**King County**  
**Department of Permitting**  
**and Environmental Review**  
35030 SE Douglas St., Ste. 210  
Snoqualmie, WA 98065-9266  
**206-296-6600** TTY Relay: 711  
www.kingcounty.gov

**RE:** Critical Areas Designation, CADS13-0003, Parcel No's. 0825069103, 9104, 9105, and the northern portion of 9102.

**Status:** Complete

LOT 2 PARTIAL CRITICAL AREAS DESIGNATION

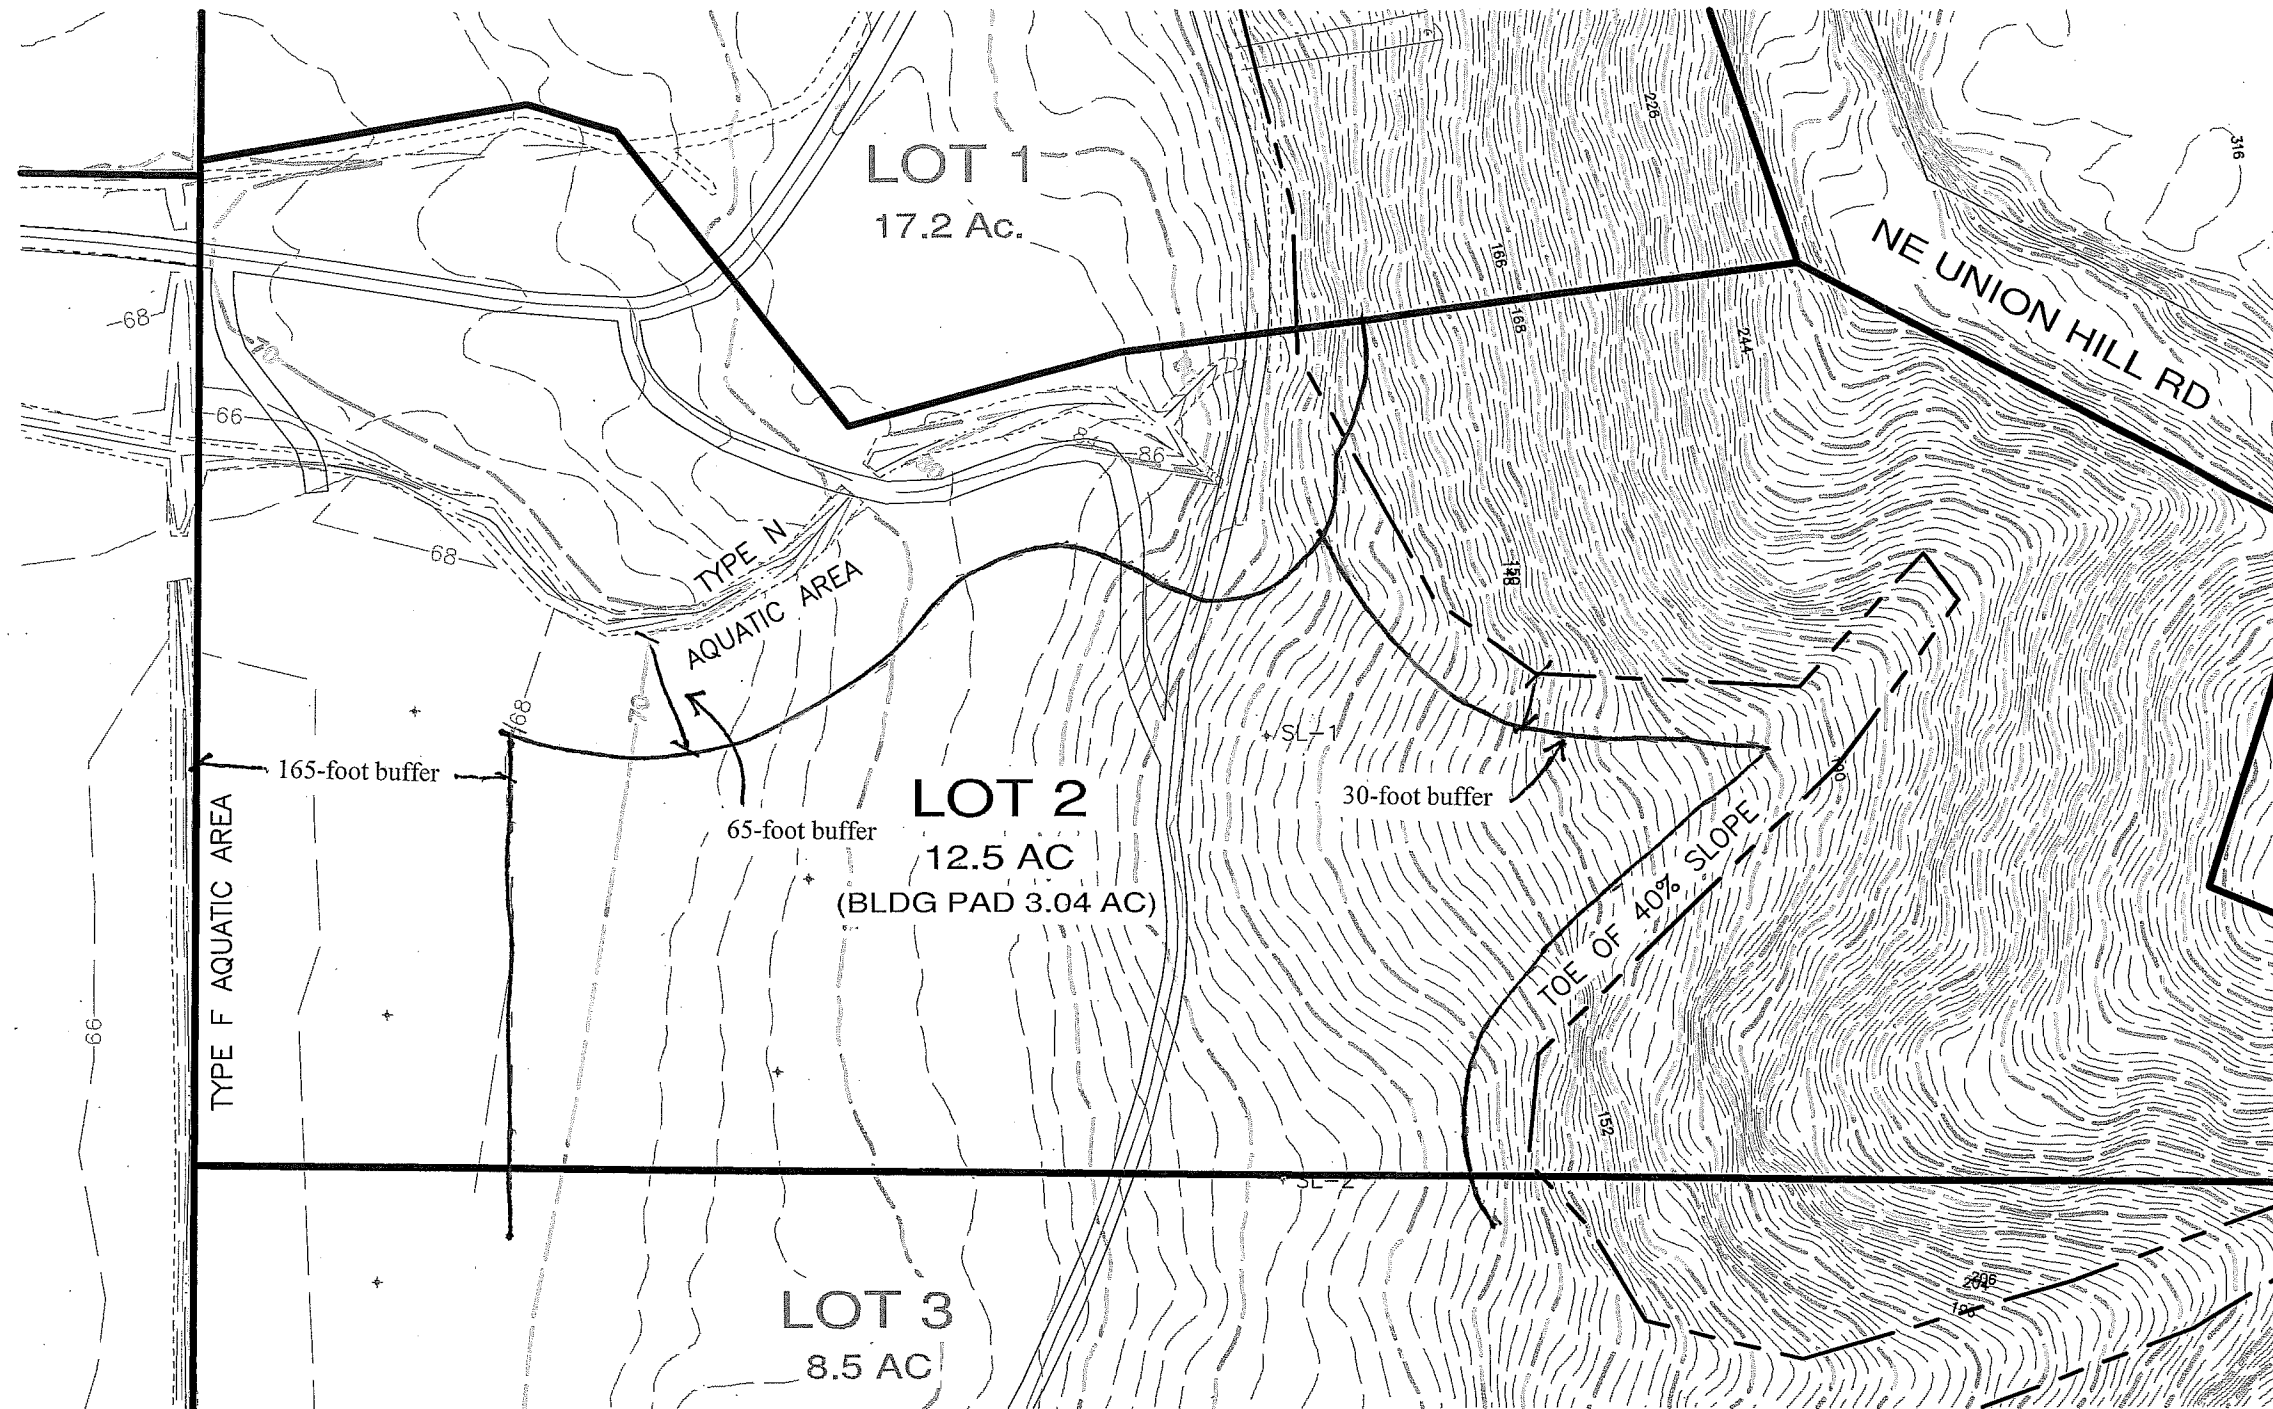
The parcels contain aquatic areas (streams) as depicted on the site plan. The streams are Type F and N, with standard buffer widths of 165 feet for the F stream and 65 feet for the N stream. The buffers area measured from the ordinary high water mark (OHWM). Within a currently undeveloped buffer, no development of any kind is usually allowed, including clearing, grading, or any other alteration of the existing vegetation. Structures must honor an additional 15-foot building setback beyond the buffer.

There are wetlands located on and adjacent to the parcels as indicated on the site plans. The wetland was determined to be Category IV with 18 habitat points per Talasaea Consultants, Inc. The county concurs with this assessment. This category of wetland within the rural area shall have a 40-foot buffer of unaltered native vegetation as measure from the wetland edge. Within a currently undeveloped buffer, no development of any kind is usually allowed, including clearing, grading, or any other alteration of the existing vegetation. Structures must honor an additional 15-foot building setback beyond the buffer.

In your case, a geotechnical report by Associated Earth Sciences Inc. dated April 5, 2012 was submitted with the application and reviewed by our staff. That report recommends a steep slope buffer reduction to 30 feet in the areas of four proposed building sites that will be created following some boundary line adjustments. The required additional 15-foot building setback will bring the total steep slope setback to 45 feet. We concur with the conclusions and recommendations presented in the Associated Earth Sciences report.
